Service Bulletin

Bulletin No.: 22-NA-041

Subject: Air Conditioning is Not Blowing Cold Air

Brand:	Model:	Model Year:		VIN:		Engine:	Transmission:
		from	to	from	to		
Chevrolet	Corvette	2020	2021	—	—	—	—

5743643

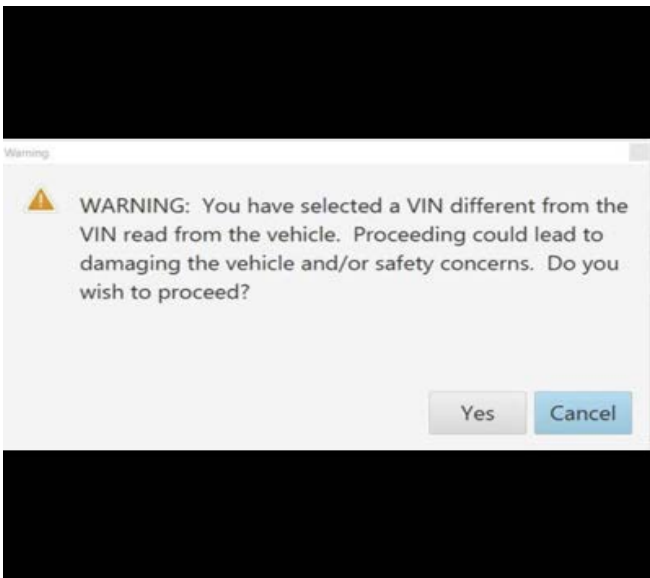
Caution: Be sure the VIN selected in the drop down menu (1) is the same as the vehicle connected (2) before beginning programming.
